**Touquoy Gold Project
Modifications – Environmental
Assessment Registration
Document Addendum No. 2**

December 21, 2022

Disposition of information requests from the May 12, 2022 letter from the Minister of Environment and Climate Change

The following table provides a disposition of the comments included in, “Table 1 Detailed Review Comments and Recommendations Regarding Appendix D.1 and D.2” from the Wood (2022) Water Modelling Third-party Review of the Touquoy Gold Project Site Modifications -Environmental Assessment Registration. Existing documentation that is referenced throughout this table includes:

Provide particle flow path tracking for the area of the groundwater model between the pit and Moose River.

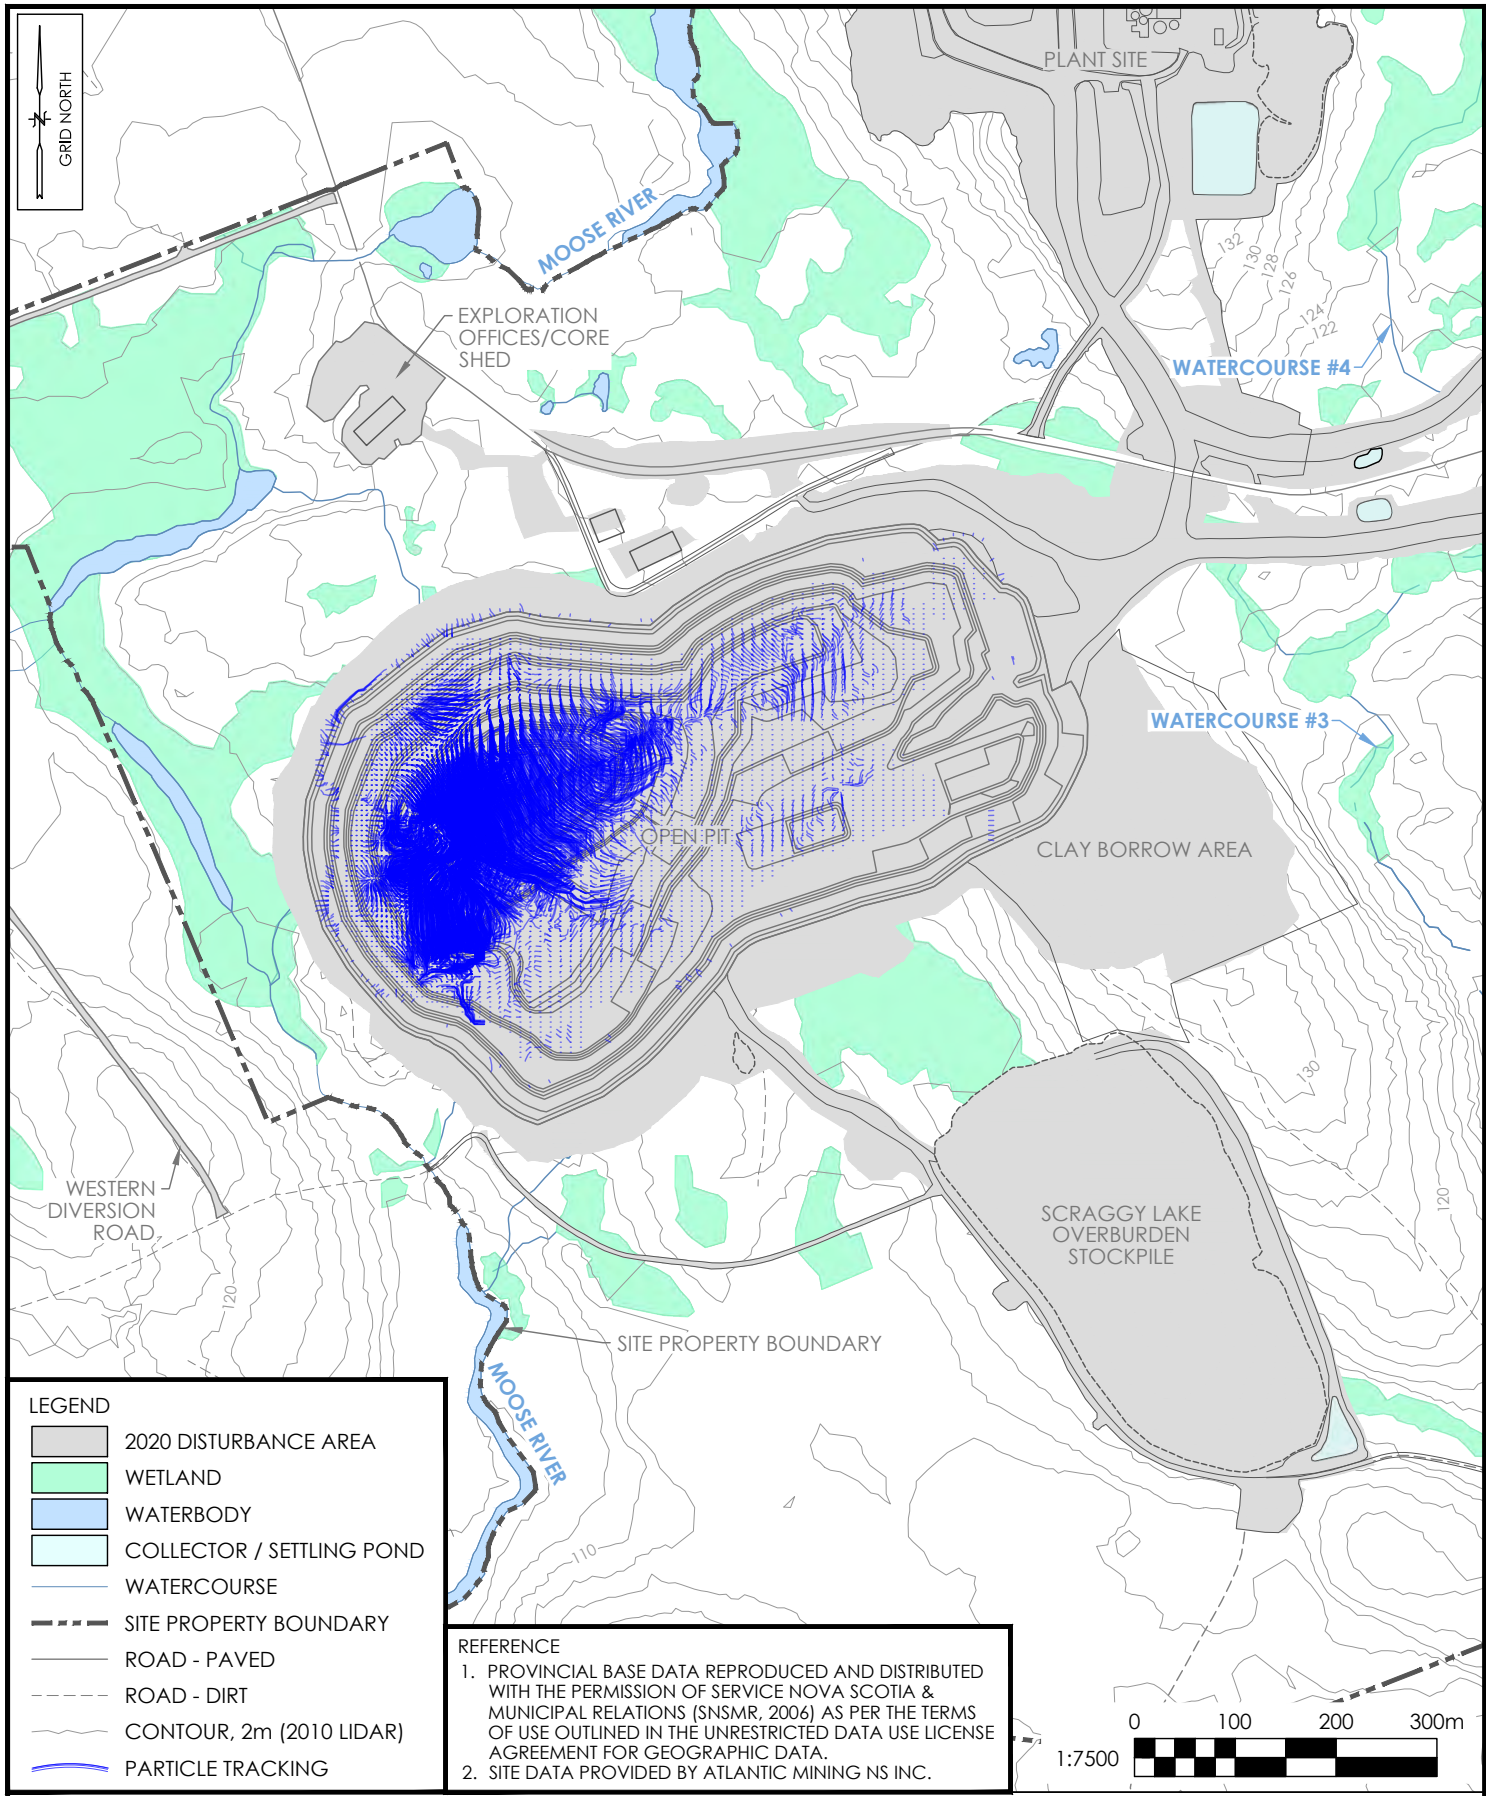
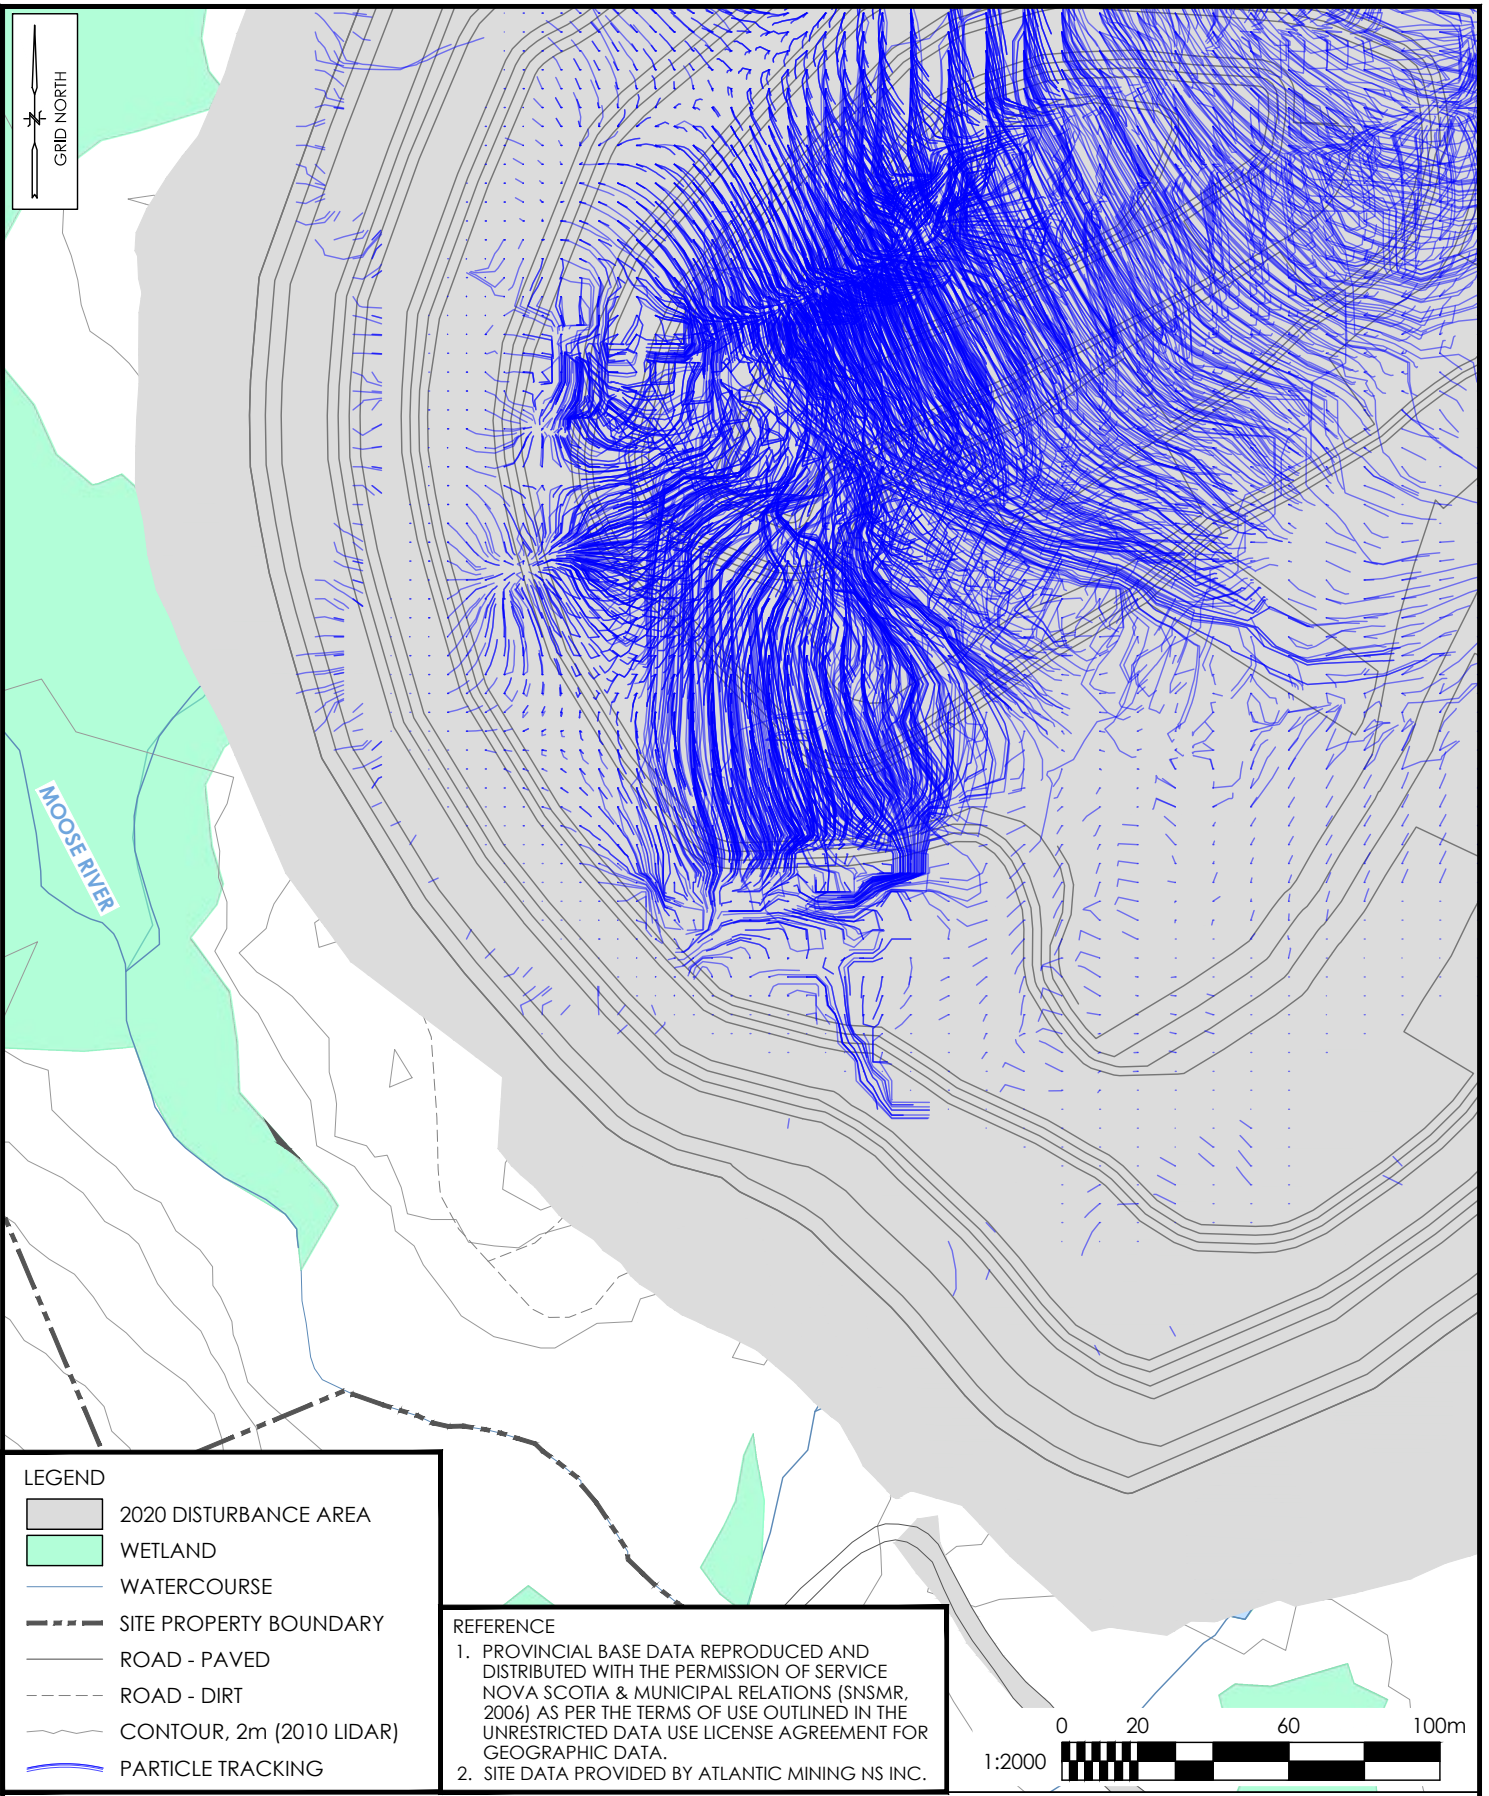
1.d	<p>Provide particle flowpath tracking for the area of the groundwater model between the pit and Moose River.</p>	<p>Refer to Attachment 3 for the full response:</p> <p>The updated groundwater flow and solute transport model included as Appendix B.3 to the March Addendum (AMNS, Stantec 2022) was used to develop particle tracks. The results presented in Attachment 3 are consistent with the site conceptual model. The particle tracks indicate that transport velocities are small and the resulting transport distances are low. This is due to a combination of relatively low hydraulic gradient between the pit and the Moose River and the estimated hydraulic conductivity of the uppermost portions of the aquifer in that region. The particle track results are consistent with the conceptual site model based on the available information, data, and model output.</p> <p>AMNS, Stantec. 2022. Addendum to the Touquoy Gold Project Modifications – Environmental Assessment Registration. Available at: https://novascotia.ca/nse/ea/</p>	<p>Attachment 3: Groundwater Modelling Additional Information</p>

In response to this request the updated groundwater flow and solute transport model described in Stantec (2022) was used to develop particle tracks represented in the figures below. Particles shown in the figures were started in each cell representing tailings in Layer 4 of the model and run for 500 years post closure. Layer 4 represents the uppermost portion of the weathered bedrock and is the shallowest layer exhibiting saturated groundwater conditions. This is consistent with the site conceptual model.

Figures 1 and 2 illustrate the predicted particle tracks. Figure 1 shows particle tracks within the full extent of the Touquoy Pit and the portion of the Moose River that flows nearest the pit. Figure 2 shows the same information but focuses on the western portion of the Touquoy Pit to better visualize the predicted distances and directions that particles moving with groundwater would cover.
